REFERENCE No. B. S. P. B. 204

ORDER UNDER SECTION 96 (2) OF ACT. III OF 1901.

PLAN OF PROPOSED 1ST & 2ND
FLOOR TO BE BUILT ON
PLOT No 52 SHEET No MR. 1
MARKET QUARTER
SCALE 8" = 1" INCH

With reference to your application dated 21-10-1929,
with a plan for the proposed building/additions and alterations on plot
No. 52, Survey Sheet No. M.H. 1, market quarter,
I have the honour to inform you that until the following requirements are
complied with, the plans cannot be passed:—

DRAWING No 629

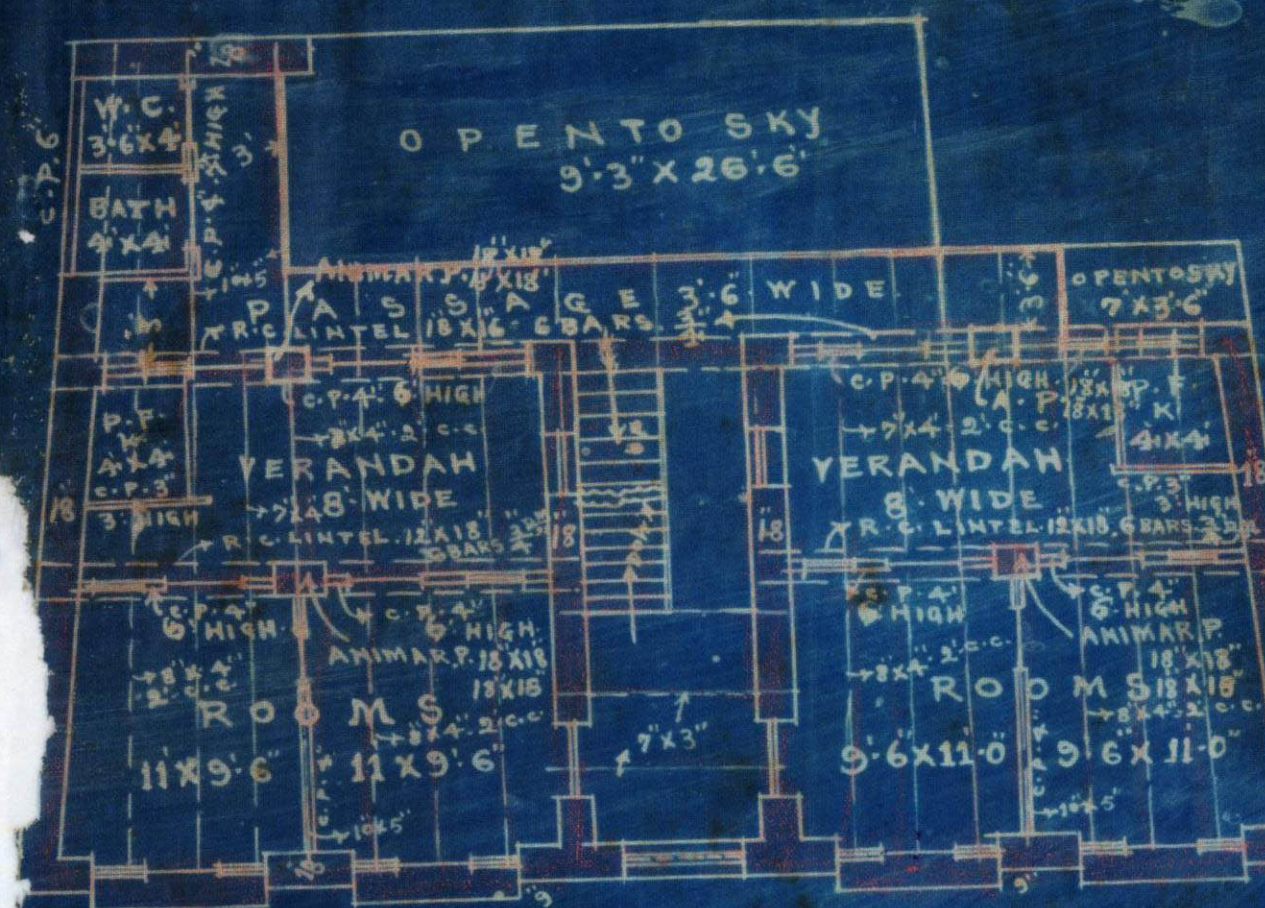
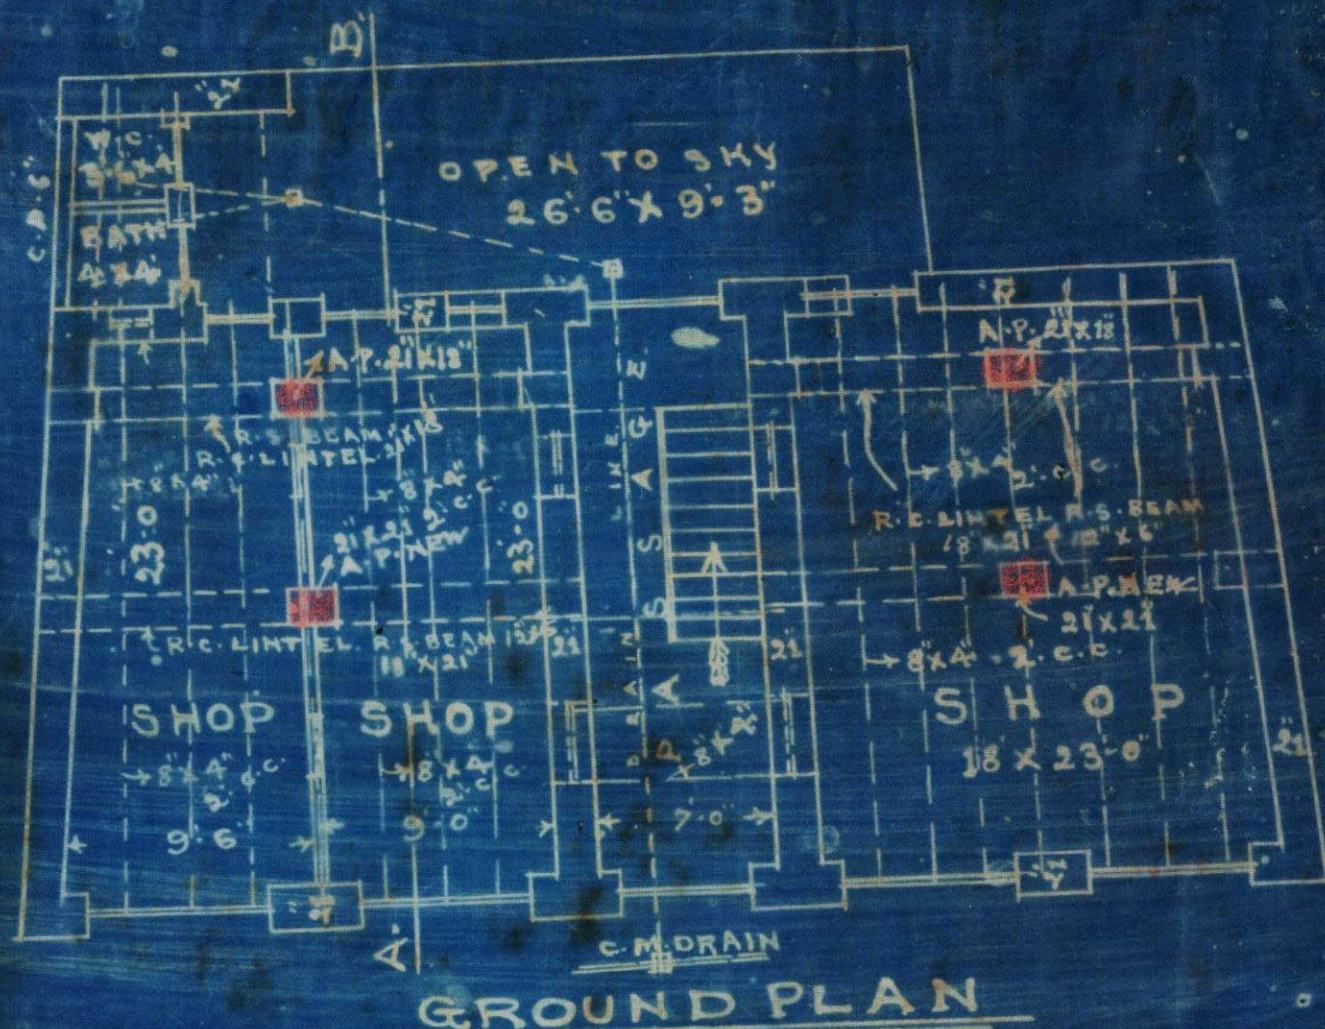
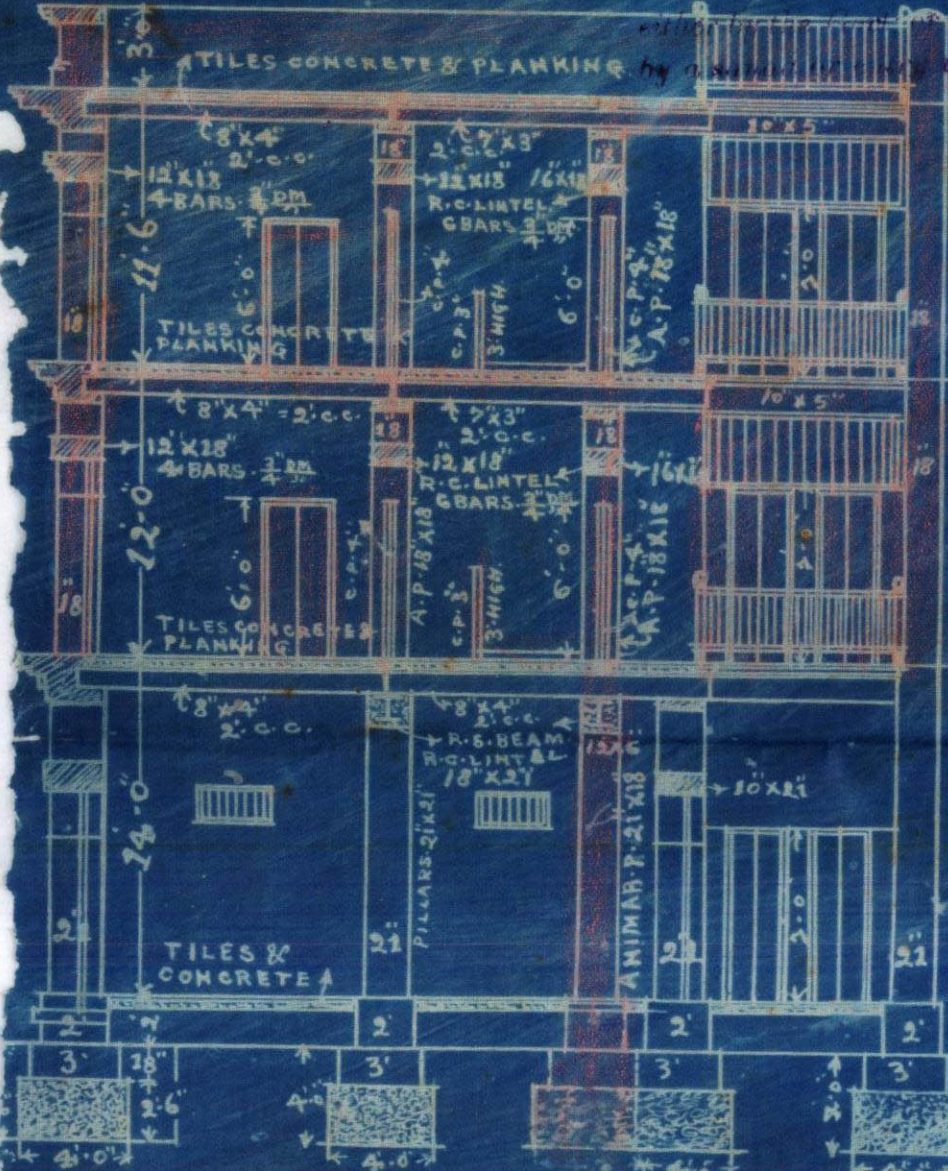
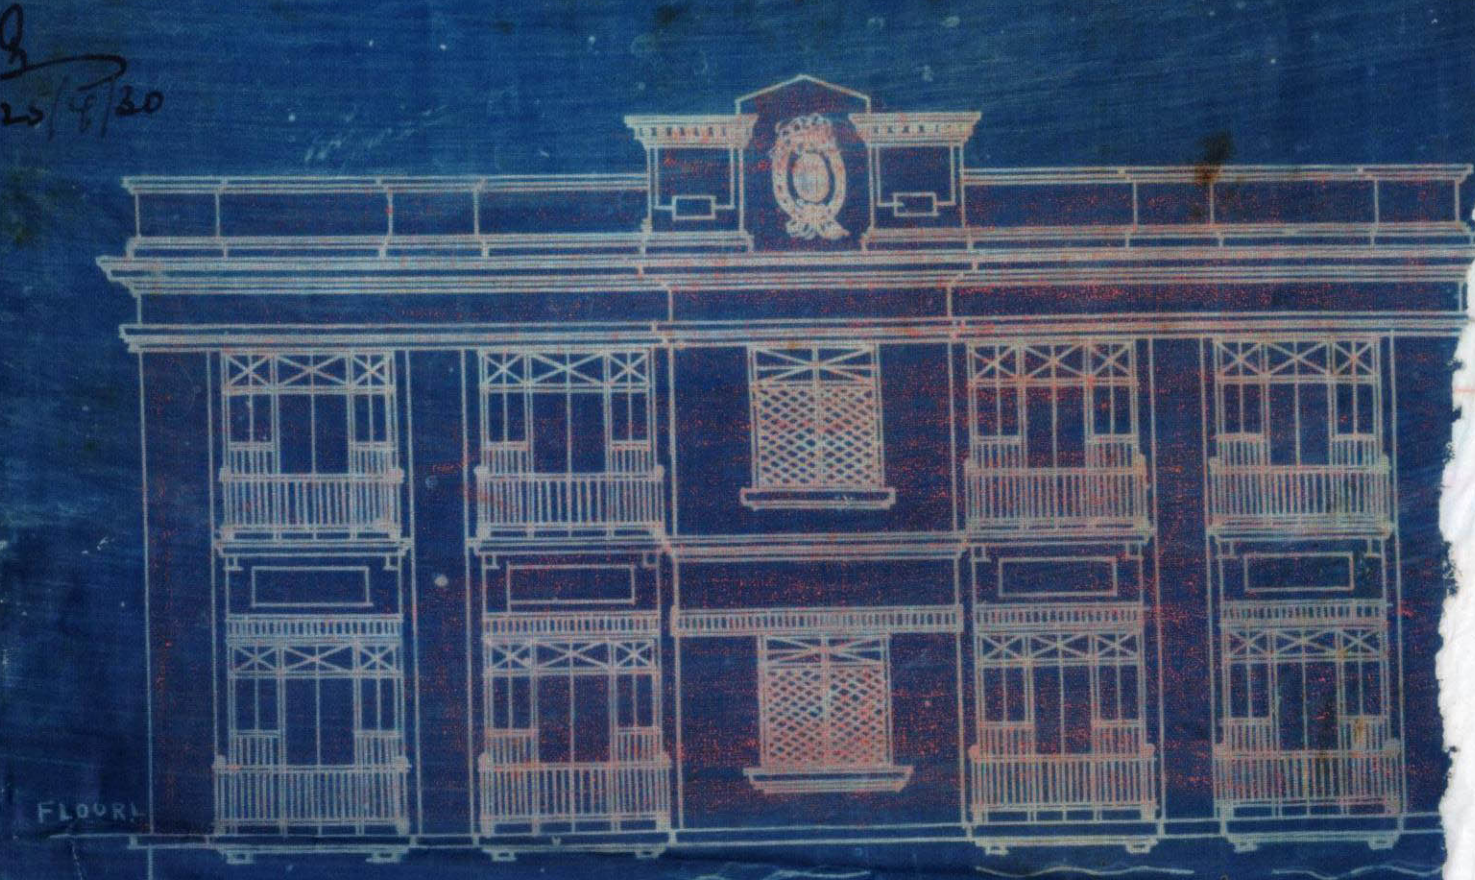
- (1) Pillar A' is not constructed 21" x 21" as shown but is less.
- (2) Foundation should be exposed for inspection.
- (3) Passage near bath room be kept open by providing iron bar grating.
- (4) Land acquired must be written as per plan.
- (5) External well & must not be opened out more than $\frac{1}{2}$ the elevation of the well.
- (6) The well & must be carried down.
- (7) The design is faulty. Why are 12" x 6" beams used where there is a pillar A in the midst.
- (8)
- (9)

(1) Pillar A is ~~not~~ constructed 21"x21" as shown but is less.

(2) Foundation should be exposed for inspection.

(3) Passage near bath and w.c. be left open by providing iron bar grating.

B's objection demands further written as per, East Wall E must not be opened out more than $\frac{1}{2}$ the elevation of the Wall. The Wall E must be carried down, the design is faulty. Why are 12' x 6' used when there is a pillar in the middle

All the objects have been completed with
excepting the wall E which is to be
carved right through. Instead of this
we have provided Rs. Man 12"x6"

(1) Pillar A shown 21" x 21" will be reconstructed
as shown red in the plan.

(2) B.S may inspect the foundations
which will be opened.

(3) Passage near bath and W.C is
already open.

(4) Land acquired has been written paid for.

(5) External wall F has been shown
to be constructed of animal pillars.

(6) Animal pillars shown in red have
been provided.

(7) In nowhere in the plans 12" x 6"
beams shown they are 8" x 4". The
Plans to be approved.
